RE: 15 ELM STREET

FEED AND GRAIN, LLC (SBL 210-7-3) SITE PLAN & FLOODPLAIN PERMIT WO# 1802.57

Review Comments:

2013 NYSGIS Aerial Image

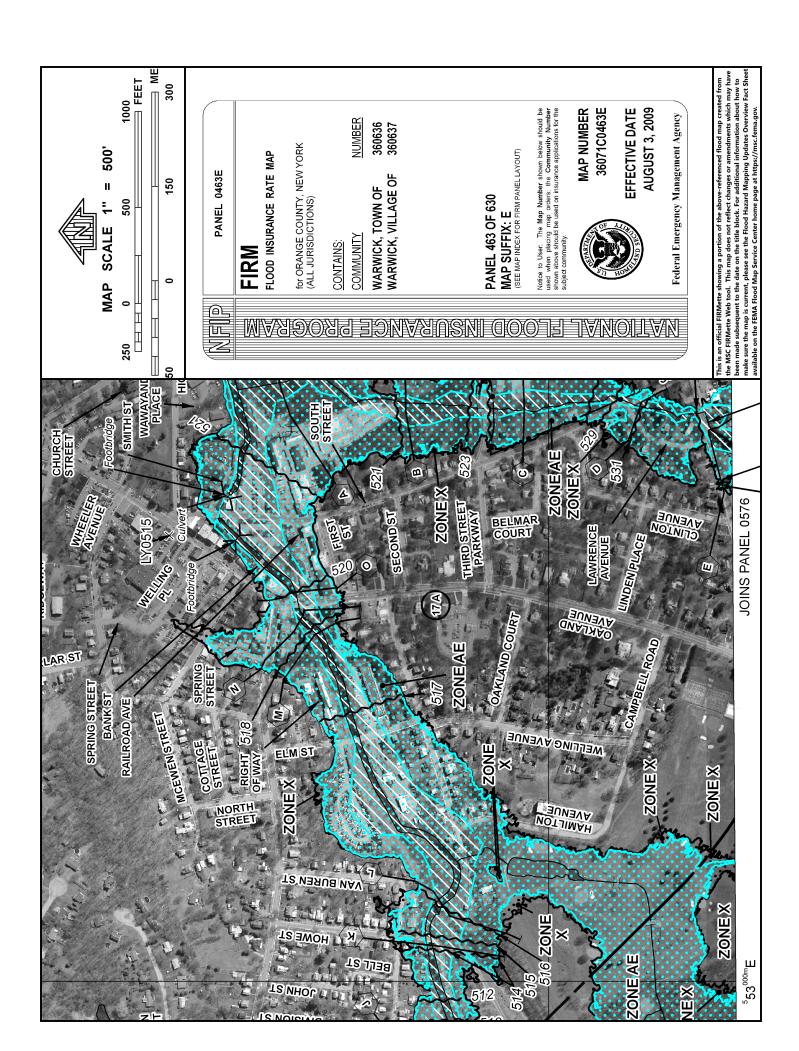
The applicant was previously before the Planning Board in 2021 for a Site Plan application for the current mixed-use occupancy of the property, and for the proposed development within the regulated floodplain. The current application is for the placement of additional fill within the designated floodplain, in the vicinity of the previous structures removed around 2013.
